## **COUNTRY CLUB COURT SUBDIVISION,** **RESUBDIVISION OF LOT 2**

**Revised for the September 20<sup>th</sup> meeting**

APPLICATION NUMBER 3 DATE September 20, 2007

## DETAIL SITE PLAN

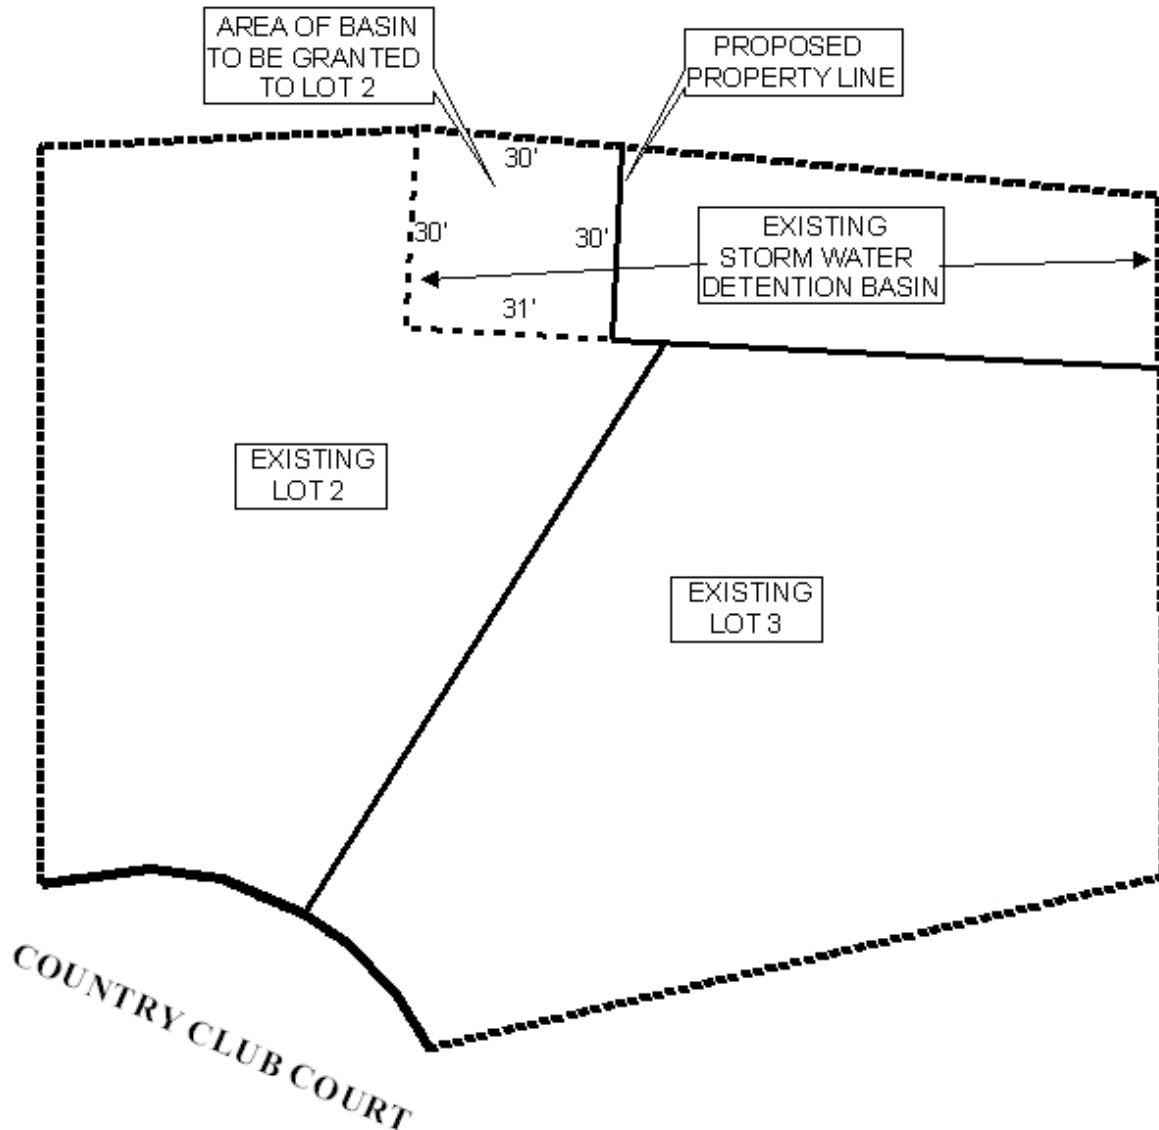
Another issue relates to the fact that the subdivision will reduce common area that is designated as/for a detention basin for the entire subdivision. Documentation that this reduction in area would not impact the performance of the detention facilities was not provided. While at first blush this may appear as appropriate for a condition of approval, it is more appropriate as a required document for tentative approval.

Generally, subdivisions are not required to have their detention fully engineered or designed at the time of Tentative Approval. However, this is not the typical subdivision application. In this instance, the detention facilities have been designed and constructed. The application is now requesting that the common area containing those facilities be reduced and incorporated into a private lot. Based upon the plat submitted, there is no information regarding the exact location of the detention basin, if it is fully within the remaining common area or partially located on the private lot.

- 1) documentation of authorization to file the application;
- 2) documentation that the reduction in the common area would not impact the performance of the detention facilities;
- 3) depiction of the detention basin structure on the plat.

The applicant has submitted a letter stating that the detention basin is contained entirely within the remaining common area, and that its function will not be impacted by the proposed resubdivision.

Based on the preceding, the plat meets the minimum requirements of the Subdivision Regulations and is recommended for Tentative Approval subject to the following conditions:
